**OFFICE OF
LICENSING &
GUIDANCE**

INSPECTORS REPORT ON A LICENCE APPLICATION

To:	DIRECTOR. P LARKIN	
From:	MALCOLM DOAK	LICENSING UNIT
Date:	3 NOVEMBER 2004	
RE:	APPLICATION FOR A WASTE LICENCE (REVIEW) FROM DONEGAL COUNTY COUNCIL, LICENCE REGISTER 24-2 , BALLYNACARRICK LANDFILL.

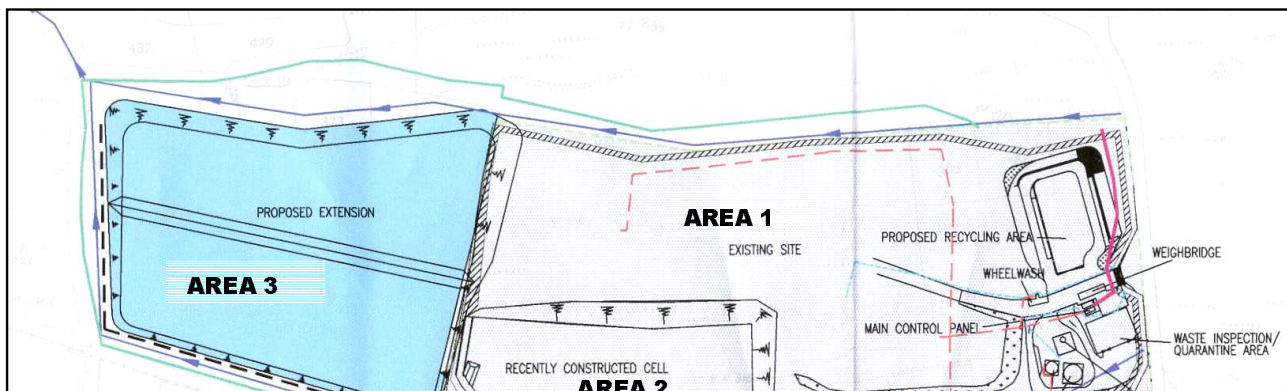
- Area 1: original waste body, unlined, final capping/gas extraction commenced;
- Area 2: lined cell, to be filled by October 2004;
- Area 3: proposed site for extension and licence review application (225,000m³ capacity).
